Designation: ~~C109/C109M – 13~~^{e1} C109/C109M – 16

Standard Test Method for Compressive Strength of Hydraulic Cement Mortars (Using 2-in. or [50-mm] Cube Specimens)¹

FIG. 1 Order of Tamping in Molding of Test Specimens

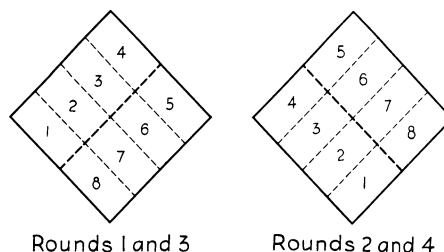
round to be at right angles to the other and consisting of eight adjoining strokes over the surface of the specimen, as illustrated in Fig. 1. The tamping pressure shall be just sufficient to ensure uniform filling of the molds. The ~~4 rounds~~ 4 rounds of tamping (32 strokes) of the mortar shall be completed in one cube before going to the next. When the tamping of the first layer in all of the cube compartments is completed, fill the compartments with the remaining mortar and then tamp as specified for the first layer. During tamping of the second layer, bring in the mortar forced out onto the tops of the molds after each round of tamping by means of the gloved fingers and the tamper upon completion of each round and before starting the next round of tamping. On completion of the tamping, the tops of all cubes should extend slightly above the tops of the molds. Bring in the mortar that has been forced out onto the tops of the molds with a trowel and smooth off the cubes by drawing the flat side of the trowel (with the leading edge slightly raised) once across the top of each cube at right angles to the length of the mold. Then, for the purpose of leveling the mortar and making the mortar that protrudes above the top of the mold of more uniform thickness, draw the flat side of the trowel (with the leading edge slightly raised) lightly once along the length of the mold. Cut off the mortar to a plane surface flush with the top of the mold by drawing the straight edge of the trowel (held nearly perpendicular to the mold) with a sawing motion over the length of the mold.
